**RE: Multi-Use Recreational Facility
Grading and Drainage Plan
Stamp Date: 10/30/17
Hydrology File: F16D003E1**

Based upon the information provided in your submittal received 11/07/2017, the Grading and Drainage Plan **is not** approved for Building Permit. The following comments need to be addressed for approval of the above referenced project:

SHEET #
C4

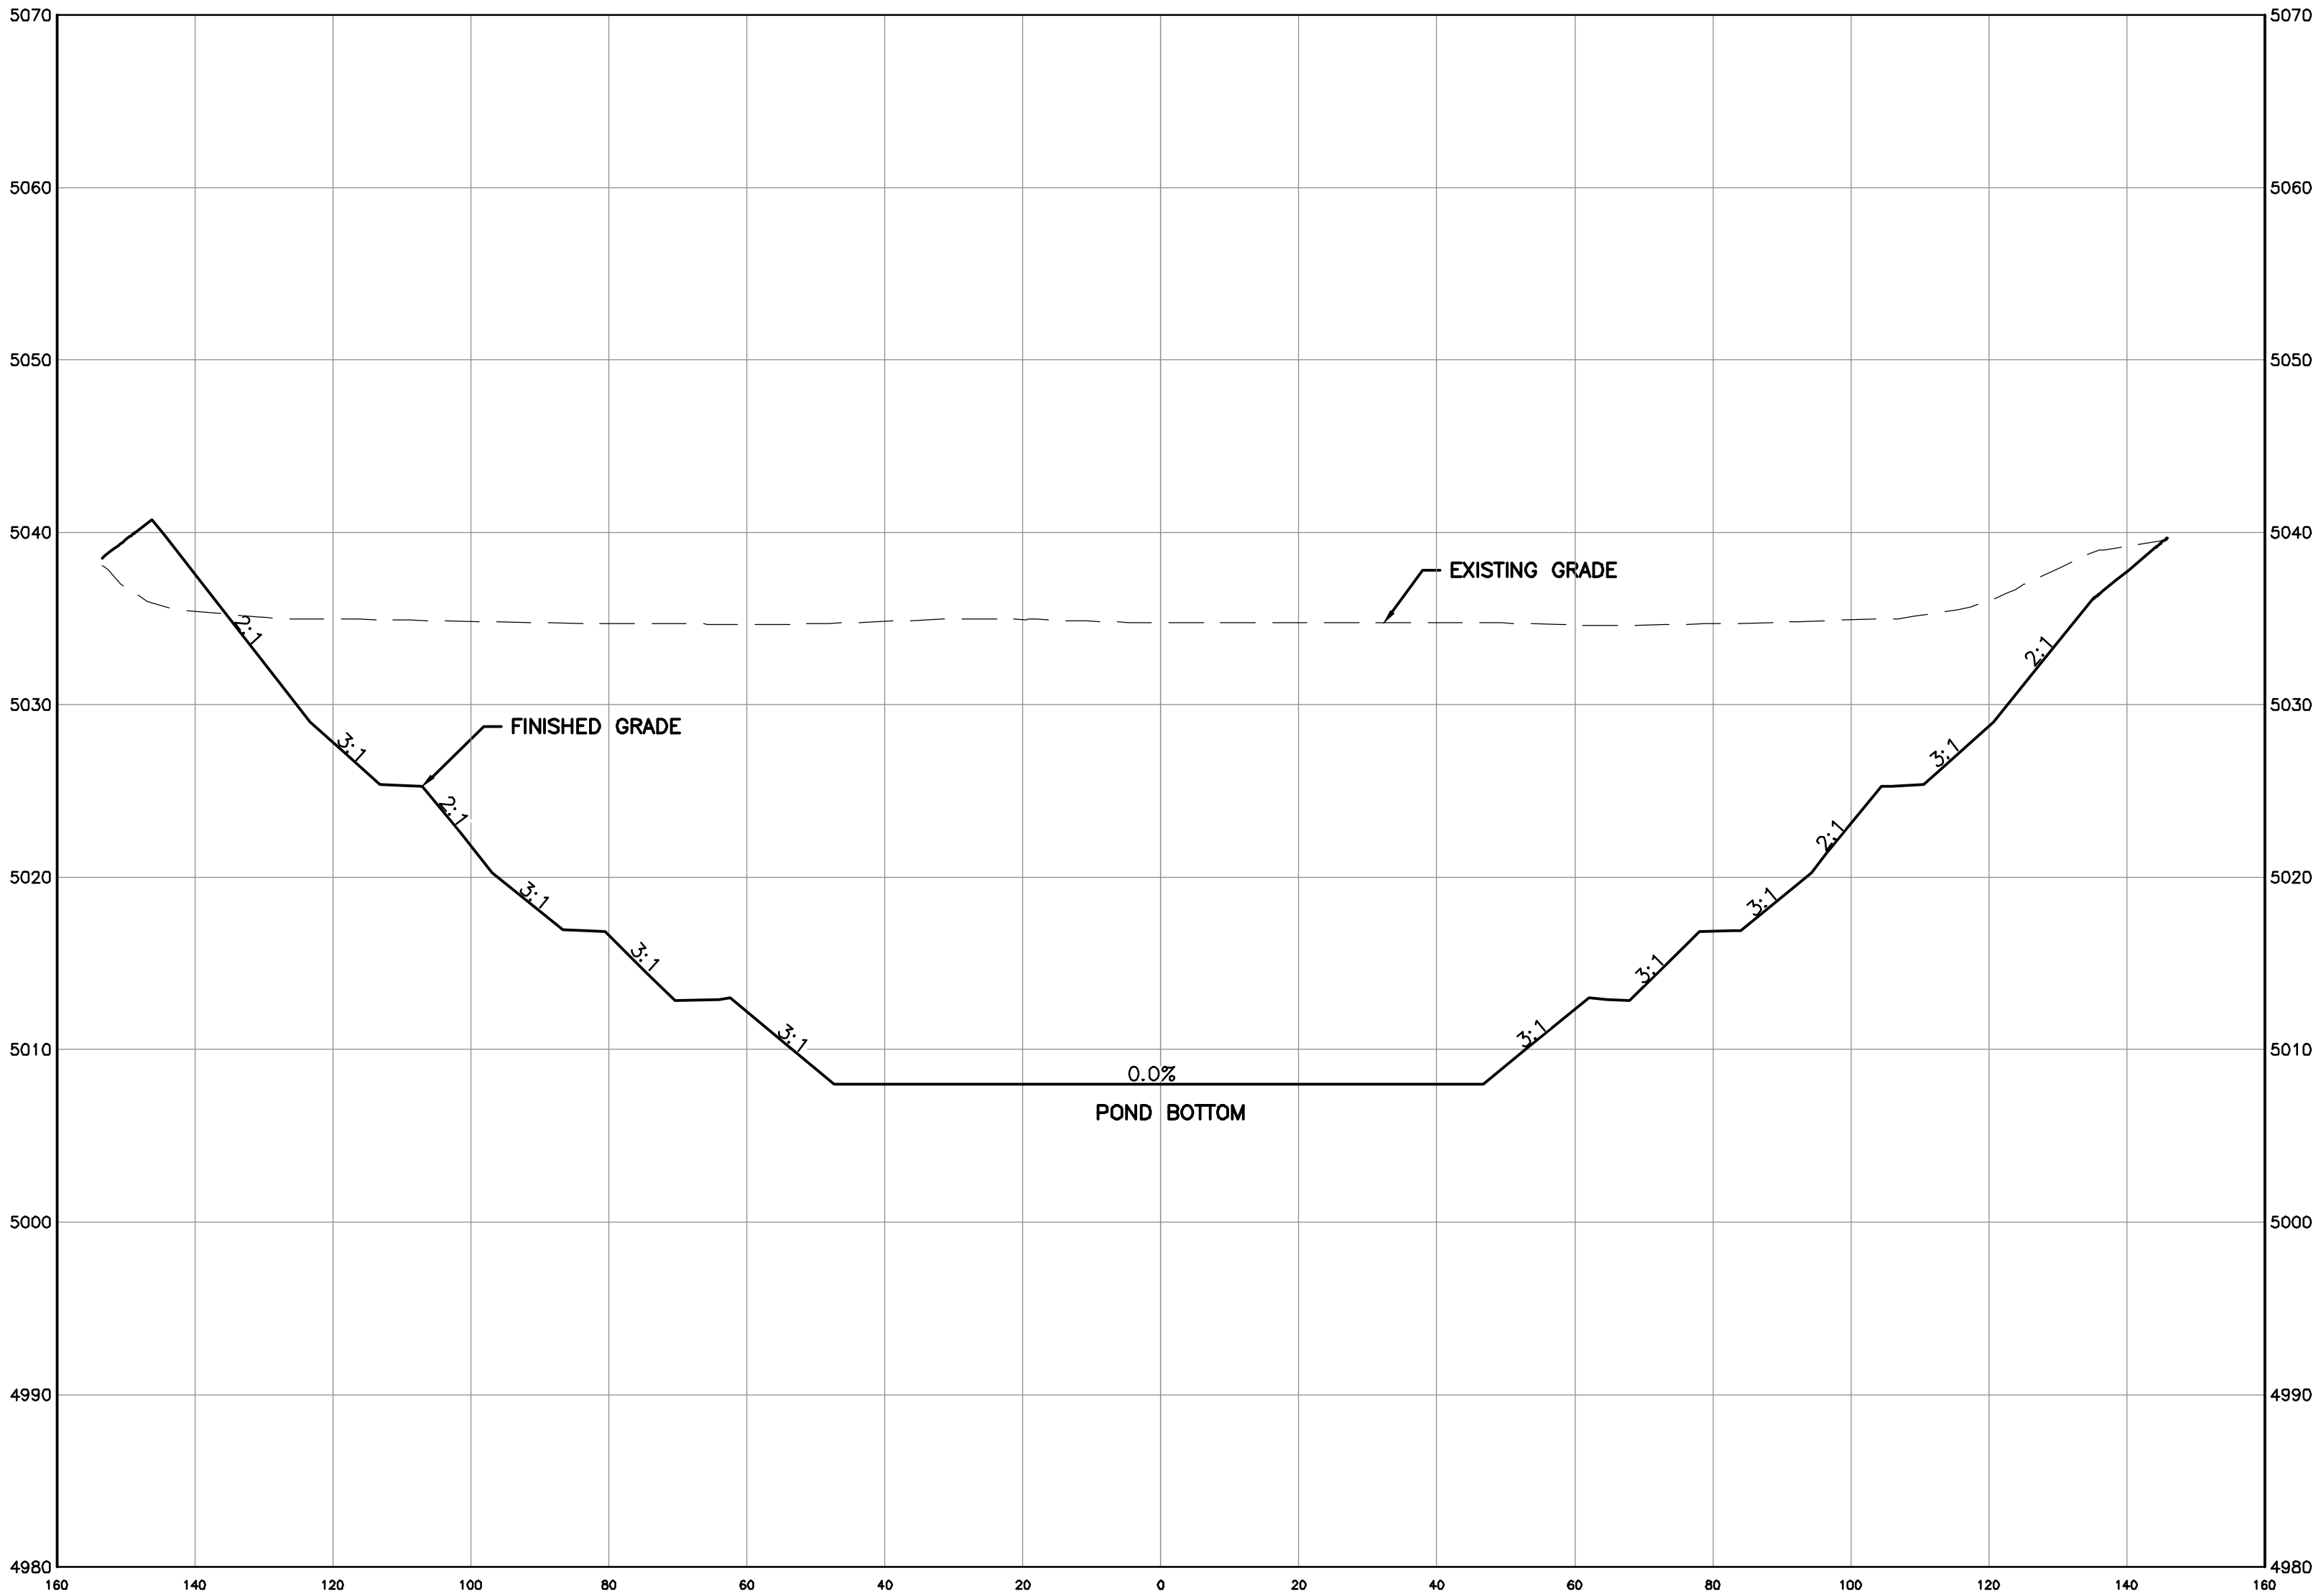
15. Sheet C3. Please add a note as how all disturbed areas are to be revegetated.
16. Sheet C4. Under the Weighted E Method for Basin 1. Please verify that the Youth Fields will produce a 26% Treatment B. This may be more.

17. Sheet C4. Under the Weighted E Method for Basin 1. The Pickle Ball Courts should be Treatment D, therefore the percentage for Treatment D should reflect this.

18. Sheet C4. Please show all calculations for the Off-site Basins or where the runoff calculations were obtained. See attachment #2.
19. Sheet C4. Please show all off-site basins that contribute to the existing storm sewer on Desert Surf Circle that is going into the proposed Retention Pond.

20. Sheet C4. Please add all Drainage Easements per recorded plat. See attachment #1. Also show recording information on Grading Plan.
21. Sheet C4. Please provide all Street Capacity calculations to show that the existing streets can handle the additional proposed runoff.

22. Sheet 4. At both proposed driveways on Desert Surf Circle, please provide the drainage area and calculations of the Q at each driveway.
23. Sheet 4. Please provide the existing inlet capacity calculations. If the current inlets cannot handle the additional proposed runoff, then additional inlets may be required.

24. Sheet 4. Please provide the existing storm sewer pipe capacity calculations on Desert Surf Circle with both EGL and HGL calculations. If the current storm sewer cannot handle the additional proposed runoff, then new public storm pipe may be required.

25. Sheet C4. **Prior to Hydrology's approval of the above referenced project for building permit, the following needs to approved and recorded:**
 - a. Need to record the proposed 20 feet Public Drainage Easement.

- b. Need to build the proposed Public storm sewer system which must be accepted by the City.
 - c. A DRB submittal may be required for an approval of an Infrastructure List for the Proposed Public Storm Sewer System and an SIA must be recorded. If there is not going to be an approved Infrastructure List, then add a note that states, "Prior to Certificate of Occupancy the public infrastructure must be constructed and accepted by the City." and also list the public infrastructure.

- d. DRC Work Construction documents for the Proposed Public storm sewer system needs to be submitted and approved. These drawings must include a profile of this Public storm sewer system with both EGL and HGL along with the calculations for them. This construction documents must be submitted to the DRC for approval.

- e. Need to vacate the portion of the existing 20 feet Public Drainage Easement once the City has accepted the installation of the proposed Public storm sewer system.

26. Sheet C4. Drainage Basins need to be revised. For example, a large portion of Basin 5 sheet drains directly into Basin 4. So this section of Basin 5 should be part of Basin 4. Also a section of Basin 3 sheet drains directly into Basin 4. So this section of Basin 3 should be part of Basin 4.

27. Sheet C4. Please provide first flush calculations and how the proposed detention pond is going to handle this volume.
28. Sheet C4. Please label the proposed retention pond area.

29. Sheet C4. Please provide the calculations for the retention pond area (the 100 year 10 day) showing the required volume and the provided volume.
30. Sheet C4. Please provide the calculation for the 100 year HGL and EGL through the proposed public storm pipe which is part of the DRC work order.

POND – CROSS SECTION A
STA. 0+79.67

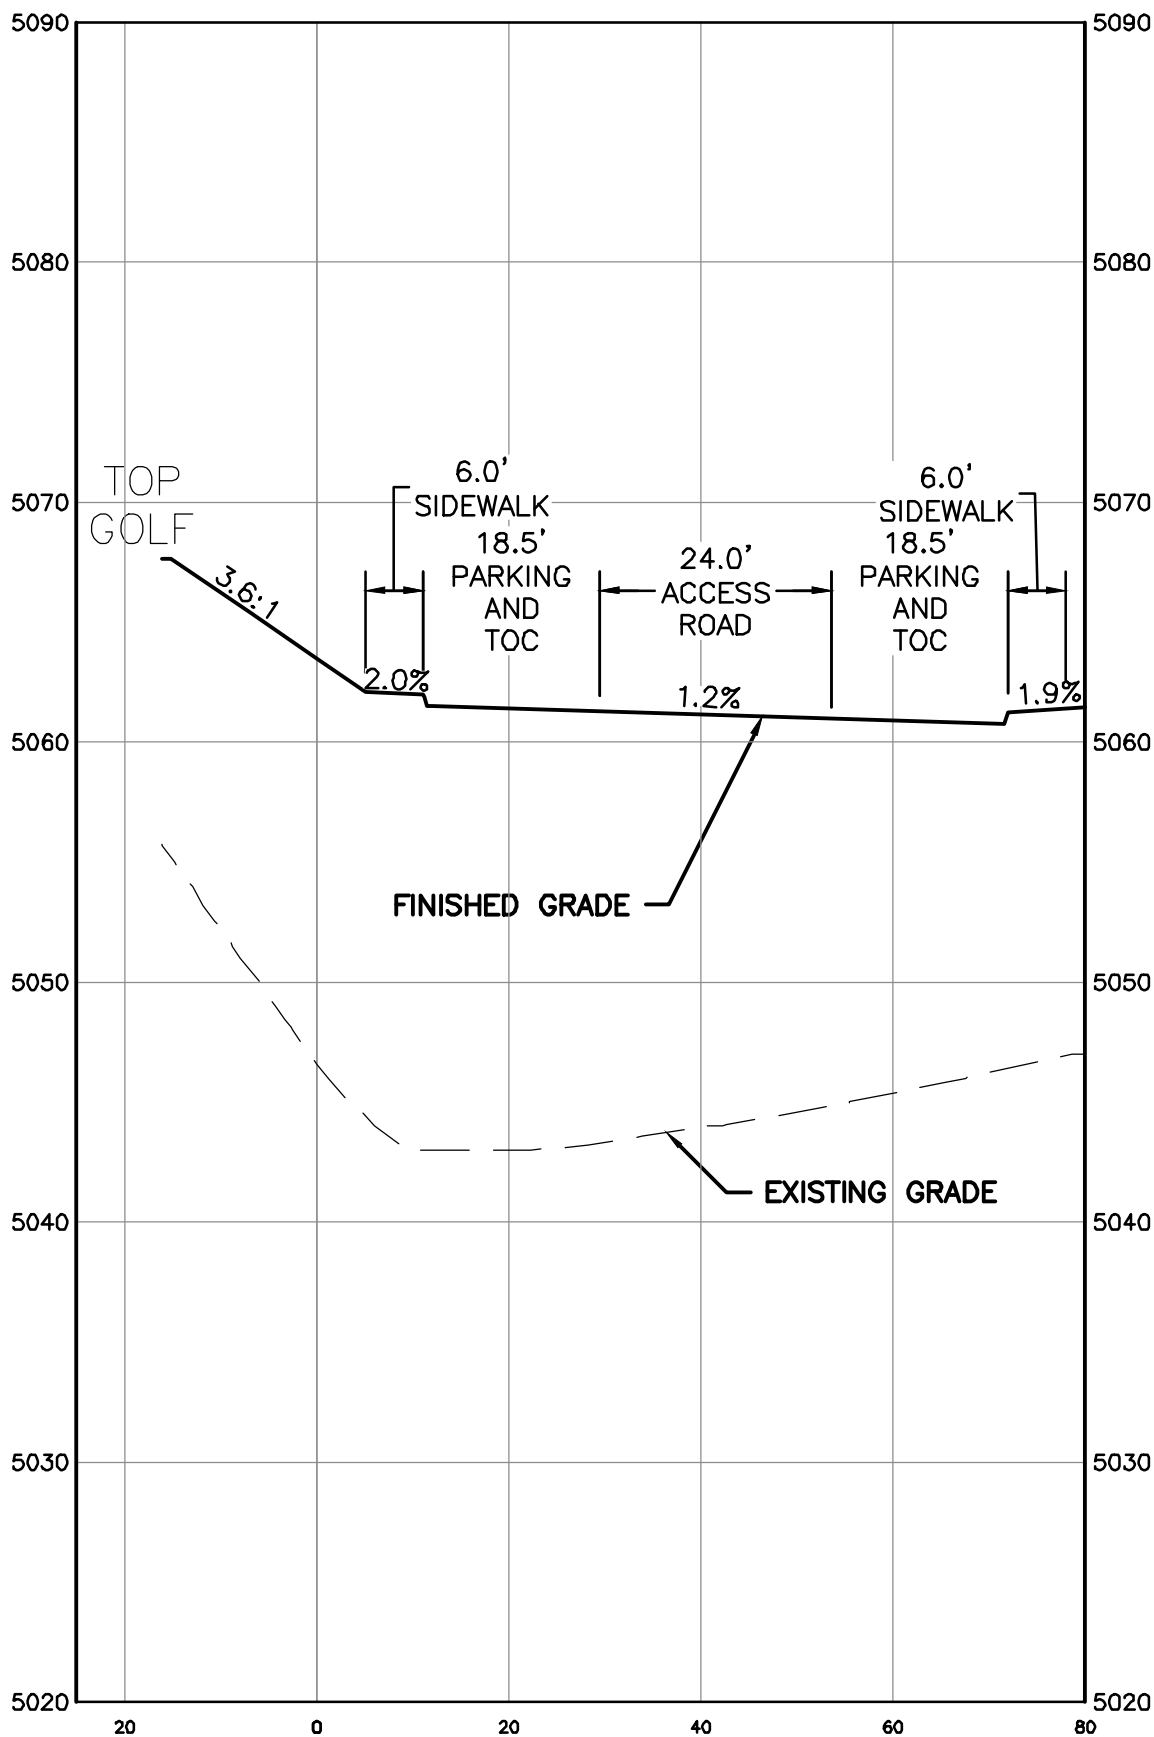
35. Sheet C5. Section A, Please show the capacity of the first flush volume in the proposed detention pond. Also provide the 100 year water surface elevation for the 10 day storm.
